New CD Drive for A730

Retrofit Kit MkII 1.630.027.00

Reason: The CD drive CDM-4 Die-Cast (1.630.010.08/69) is no more available. Therefore, the Retrofit Kit MkII (with CD drive CDM-4/19) has been developed. The following text contains step-by-step upgrade instructions.

Fig. 1: Servo Board (assy. no. changed from 1.630.051.86 to 1.630.072.00 after the modification)

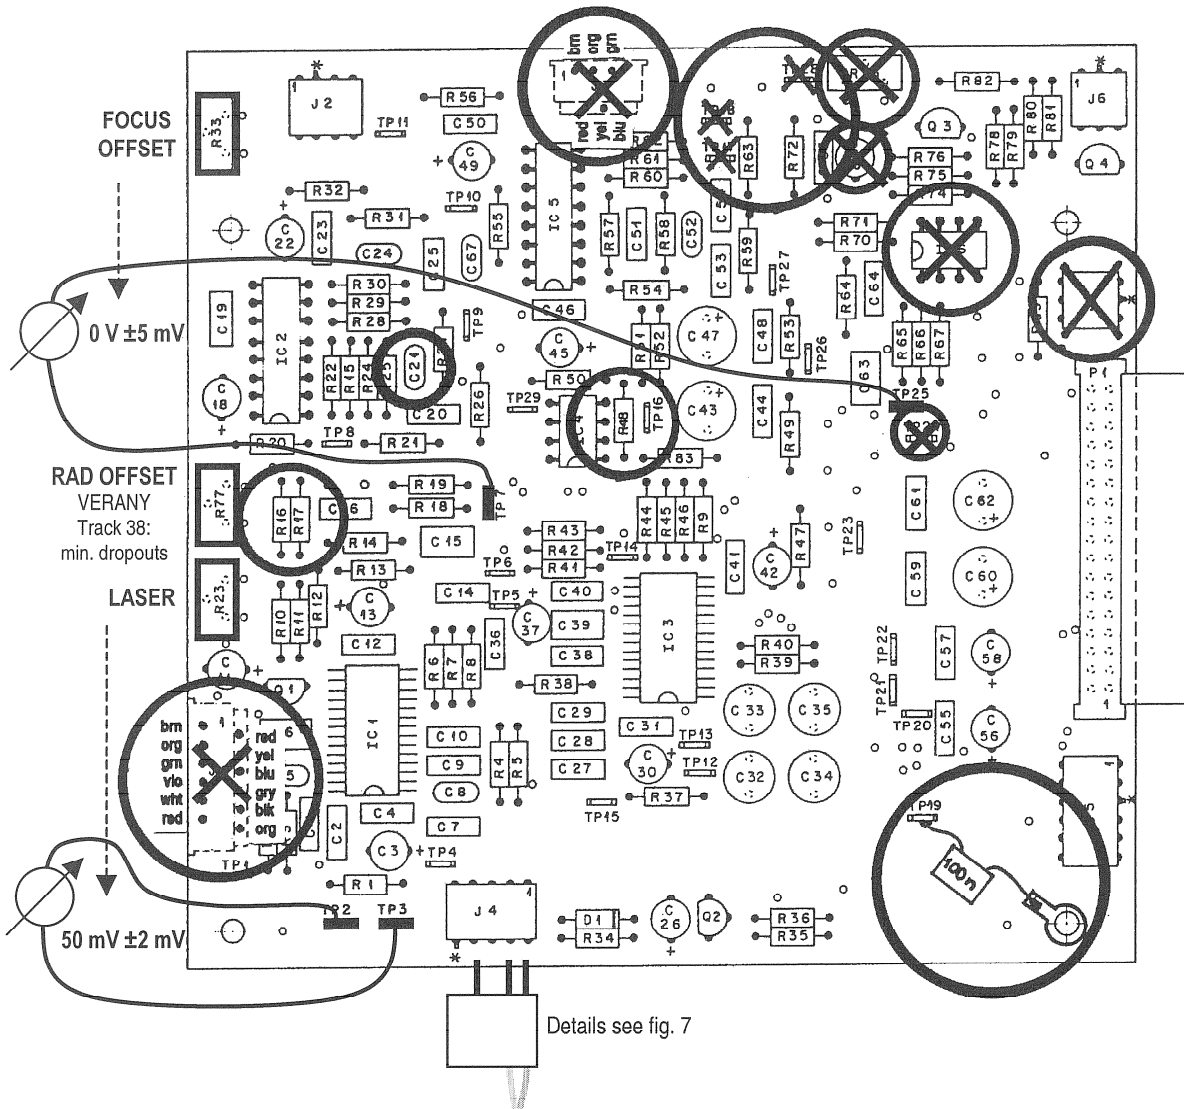
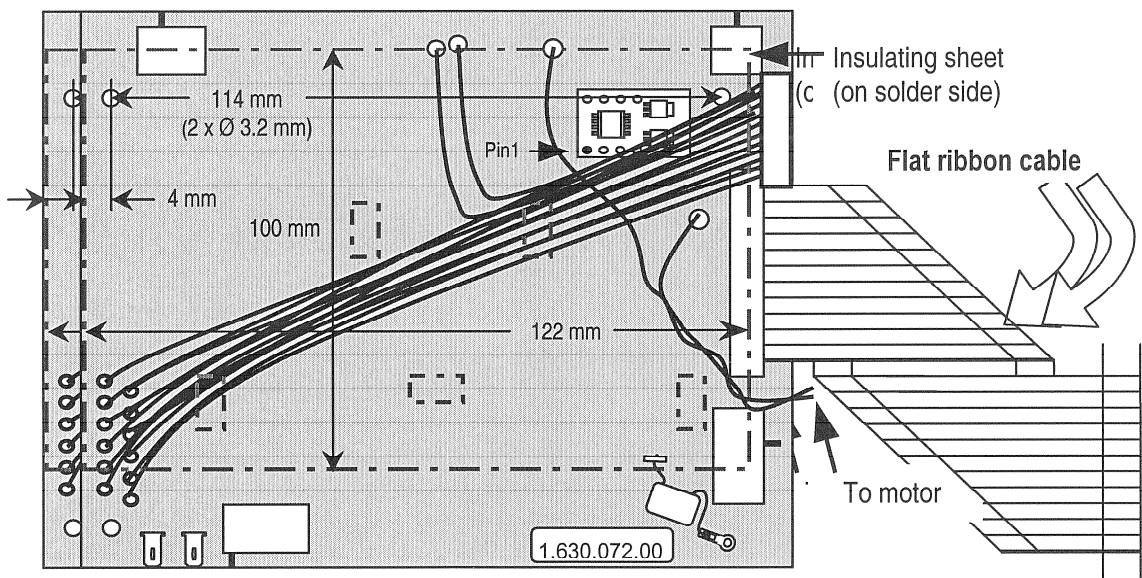
- Remove the following parts: TP17, TP18, TP24, TP28, J1, J3, J7, C66, R73 (trimmer pot), and IC6.
- Install the small Driver Brush Motor PCB (1.630.075.00) at the location of IC6; for details on its orientation please refer to fig. 1 and 2.

- The 100 nF capacitor (59.03.2104) is connected to TP19 (HF-RET); its second terminal is soldered to the solder lug (29.26.1002), refer to fig. 1. Test points TP2 and TP3 must be bent by 90°, refer to fig.1; we urgently recommend to unsolder them before bending.

- Solder the pre-fabricated wires (1.630. 114.93) to the corresponding solder pads according to the table below and to fig. 1 (at the former positions of connectors J1 and J3). Fix the connector to the PCB with a piece of adhesive foam tape (fig. 4). Tie the cables with the wire straps (35.03.0109) according to fig. 4 and 5. Solder the two twisted wires (brn, blk) to the corresponding pads on the PCB (refer to the table below and fig. 1).

- Cut a rectangular insulating sheet (dimensions: 122 x 100 mm) out of the insulating sheet put aside before; refer to fig. 1. Fix this insulating sheet as shown in fig. 3 to the solder side of the Servo Board, using five pieces of the double-sided adhesive foam tape contained in the kit. The foam tape has to be positioned according to fig. 1 and 3; press the insulating sheet firmly to the foam tape.

- Drill two holes Ø 3,2 mm into the insulating sheet such that they match the two mounting holes of the PCB.
- Fold the flat ribbon cable as shown in fig. 1. Stick the label "1.630.072.00" over the label "1.630.051.86" and solder the two twisted wires to the motor's soldering tags (brn wire to red dot). Reinstall the Servo Board. If using the additional Service Kit 1.630.060.00, replace the 3-pin housing of the lock solenoid connector (plugged to socket J4) by the 5-pin housing contained in this kit, refer to fig. 7.

Fig. 3: Cut pin and wire ends on Servo Board; Insulating sheet w. 2 holes, fixed on solder side with 5 pcs. of self-adhesive foam tape

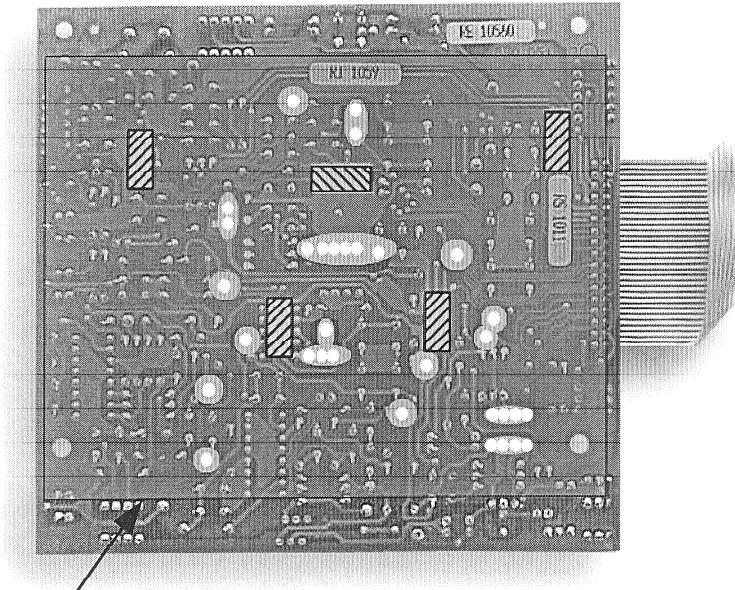
- Caution:** *The clearance between the CD drive and the Servo Board is extremely narrow; therefore the component leads on the solder side marked grey in fig. 3 must be cut very short.*

Fig. 6: Wire placement on Main Board (no wires in "Chassis Area"!)

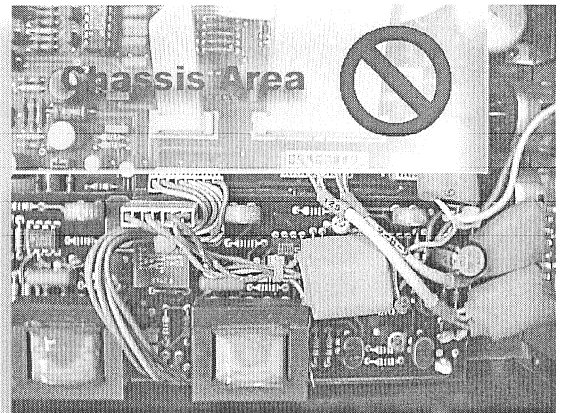
- Replace the label "1.630.052.22/23/24" by the label " 1.630.070.20".
- Reinstall and connect the Main Board. **Caution:** Take care to the placement of the wires with the filters (possibly in shrinking tube) relative to the Line Amplifier (refer to fig. 6). When installing the front panel, these filters must neither be touched nor pinched.

Fig. 7:

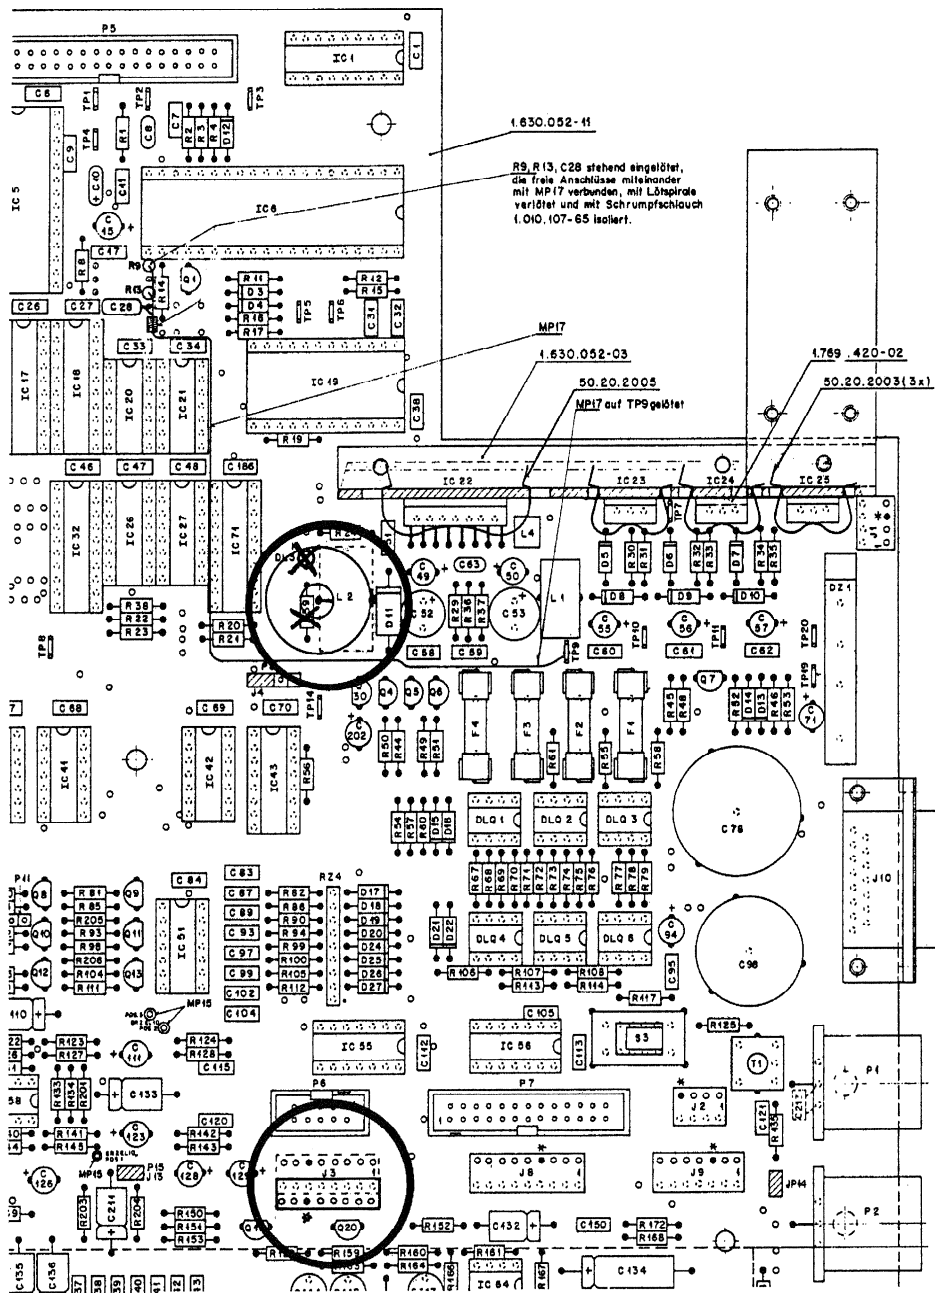
On the Servo Board 1.630.051.85/86 a 5-pin connector is used for the connection to the lock solenoid (the former version 1.630.051.00 had a 3-pin connector). Remove the two pin contacts from the former connector housing by carefully pressing down the detent spring with a pointed tool while pulling. Slightly bend the detent springs of the pin contacts up again and insert them into the 5-pin connector housing (contained in the kit 1.630.060.00). The flat part of the connector housing must face upwards when plugging it into J4 on the Servo Board.

Modified Servo Board Diagram

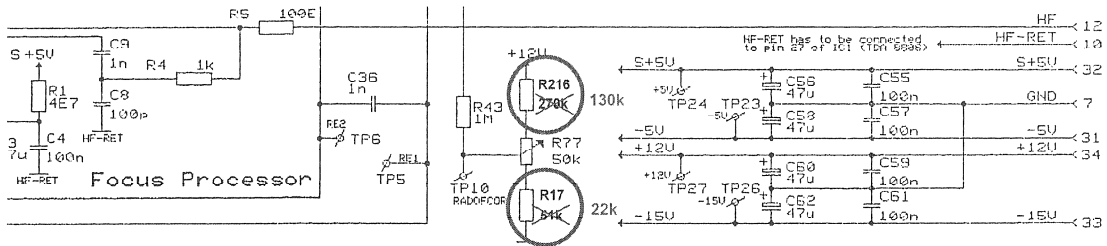
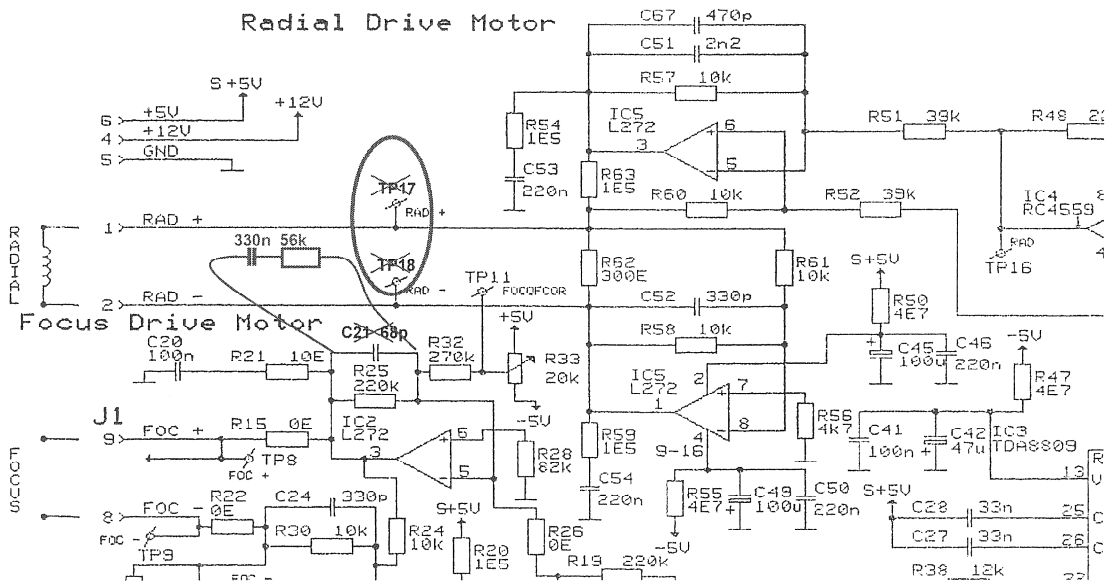
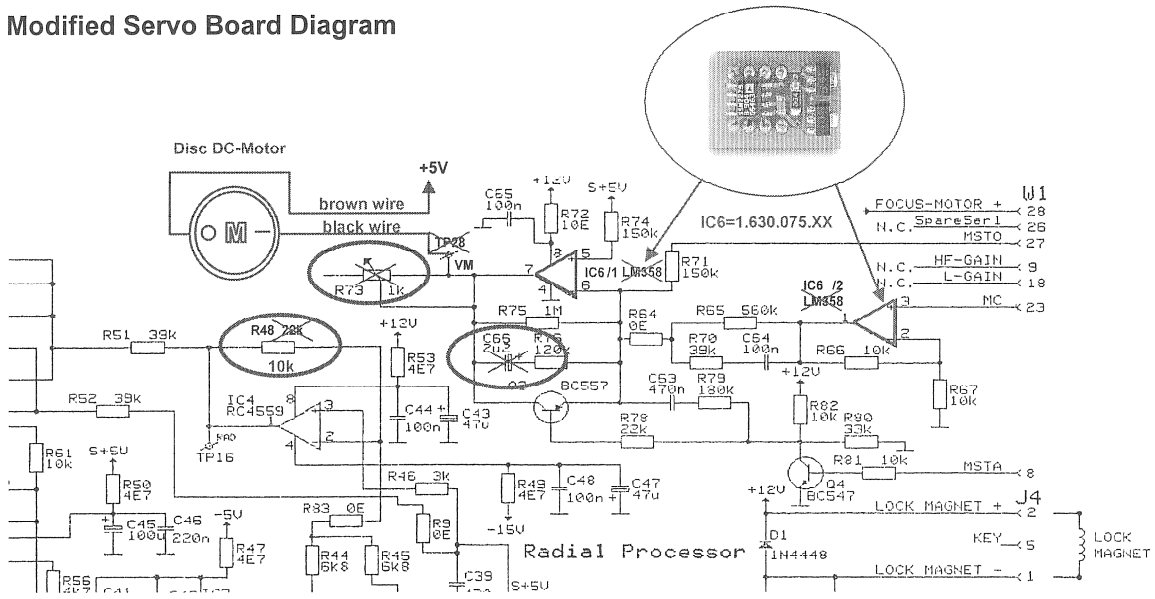
- Take care to use only appropriate tools for unsoldering and soldering!*
- Perform the following modifications on the Board (1.630.051.85/86):
- R48 (22 kΩ), replace by 10 kΩ (57.11.3103).

- R16 (270 kΩ), replace by 130 kΩ (57.11.3134).
- R17 (51 kΩ), replace by 22 kΩ (57.11.3223).
- C21 (68 pF) , replace by 330 nF (59.06.0334) in series with 56 kΩ (57.11.3563).

Transport Lock

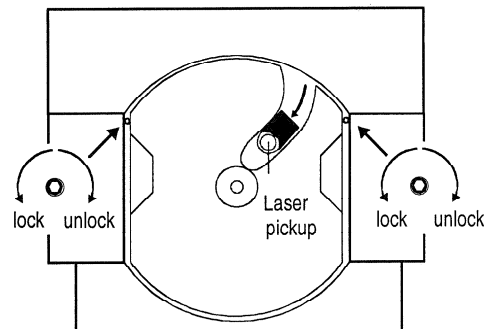
The new CD drive has a mechanical transport lock. Before transporting the unit, two hex screws 2.5 mm must be tightened (approx. 10 turns *counterclockwise*). If so, the drive is fixed in a defined position. Make sure to insert the "Transport Lock" sheet (1.630.110.38, contained in this kit) into the CD compartment after having closed the transport lock. These screws must be released (approx. 10 turns *clockwise*) before the unit is put into operation again.
